Saddlebag Location On 2004 Models

Tech Tips #57 - December 8, 2003

Figure 2: Bracket in its new position.

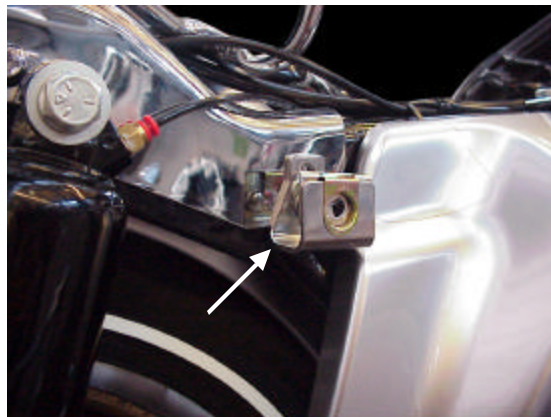
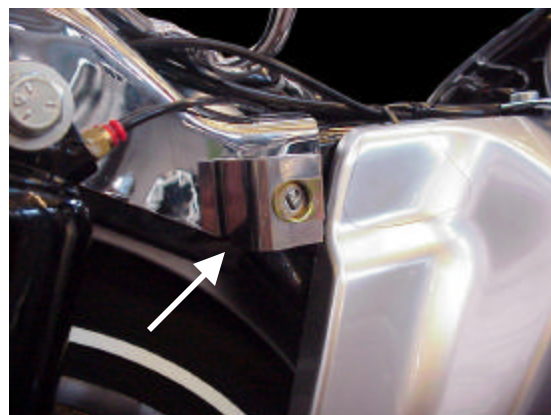
The orientation of the two front saddlebag brackets, part number 47449-97, was recently changed on standard production 2004 FLT family motorcycles. The brackets were rotated 90° (see Figure 2) to move the front of the saddlebags up and rearward. This provides additional clearance with the side covers.

1. Remove the saddlebag and loosen both front and rear saddlebag bracket bolts.
2. Rotate the front bracket 90°, from the position in Figure 1 to the new position shown in Figure 2. The top of the "U" now faces forward.
3. Move the saddlebags rearward as far as the support will allow.
4. Insert the bail head studs to align the saddlebags
5. Without disturbing the bracket positions remove the saddlebags and tighten the bracket bolts.
